**RC10
B6.4
TEAM KIT**

RC10B6.3 vs. RC10B6.4 Comparison

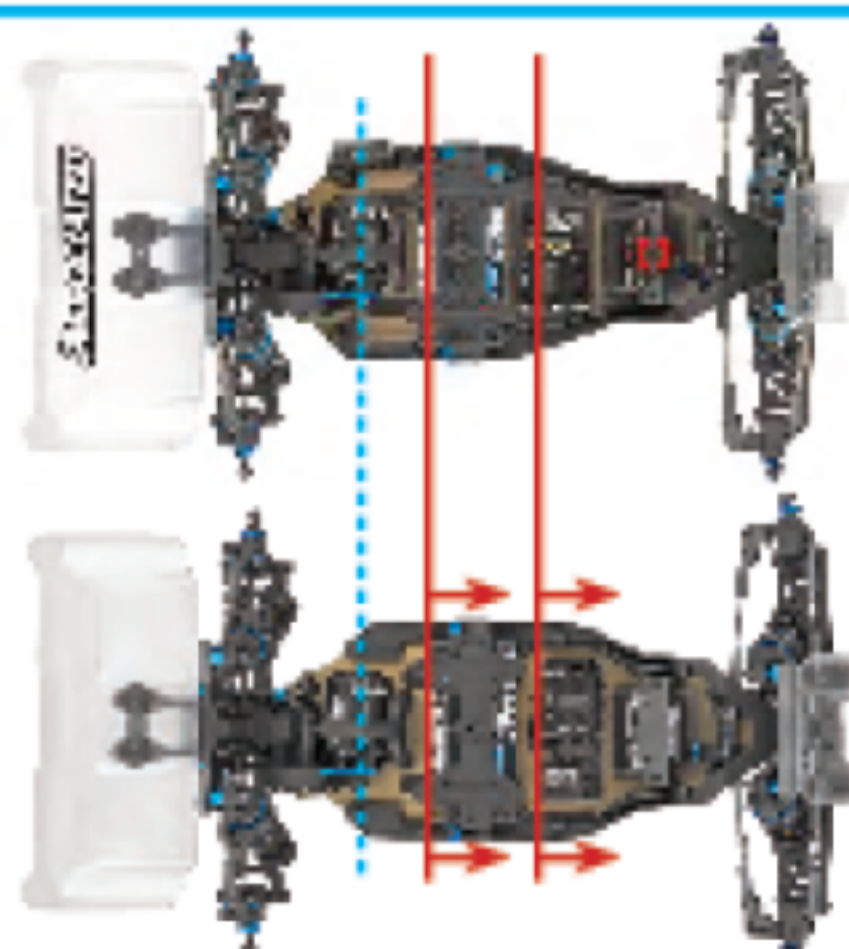
Updated top plate and ballstud mount

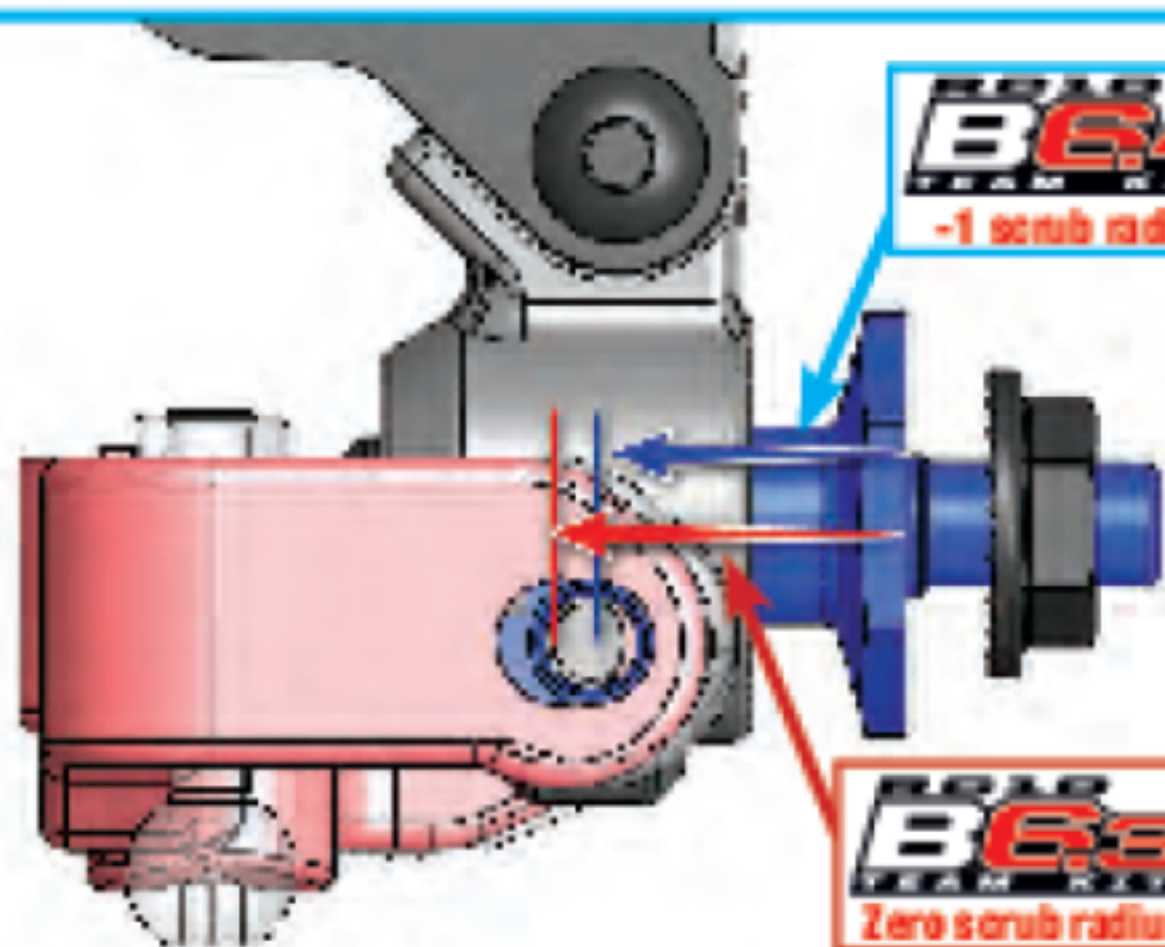
New adjustable height steering system.
B6.3 is not adjustable

-1 scrub radius

Zero scrub radius

-1 caster/steering blocks move the pivot closer to the wheel center for smoother steering
